Refer to: HSA-10/WZ-107

Thank you for your letters of September 4, 2001, requesting Federal Highway Administration (FHWA) acceptance of your company's **Energy Dispersement Cell Barricade (EDCB)** as a crashworthy traffic control device for use in work zones on the National Highway System (NHS). Accompanying your letter was a report of crash testing conducted by the Texas Transportation Institute and videos of the tests. You requested that we find this device acceptable as a Test Level 3 (TL-3) devices, respectively, for use on the NHS under the provisions of National Cooperative Highway Research Program (NCHRP) Report 350 "Recommended Procedures for the Safety Performance Evaluation of Highway Features."

Energy Dispersement Cell Barricade - TL-3

FRONT VIEW

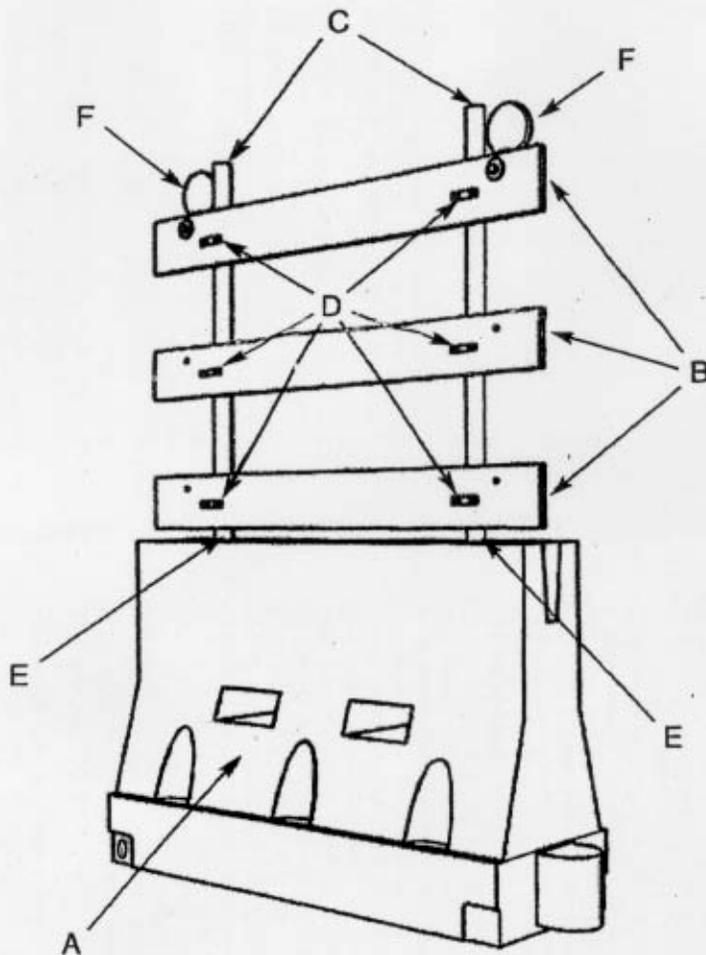
The Model 2001 Type III **EDCB** tested full of water, exceeded the velocity change requirements for a work zone traffic control device. However, its intended use is to hinder access to an area and be difficult to move. The researchers calculated that the occupant impact velocity of 5 meters per second would not be exceeded if the volume of water was reduced by half in these units. Therefore, we conclude that the Model 2001 Type III barricade will be acceptable for road closures in if the cell units are used half filled with water (482 kg of water). The fill mark or other method of regulating the maximum water line must be permanently incorporated into the EDCB units. An additional condition is that they not be placed in a location where traffic running perpendicular to the closed road cannot impact the end of a EDCB installation as they have not been crash tested at the 90 degree orientation.

Because this device has been tested and met the unique requirements that had been set for them, the device described above and shown in the enclosed drawings for reference is acceptable for use on the NHS under the range of conditions tested and the additional conditions discussed above, when proposed by a State. In addition, the Model 2001m EDCB, the base unit of which is 812 mm tall, will also be acceptable subject to the same conditions and restrictions as the crash-tested Model 2001 EDCB.
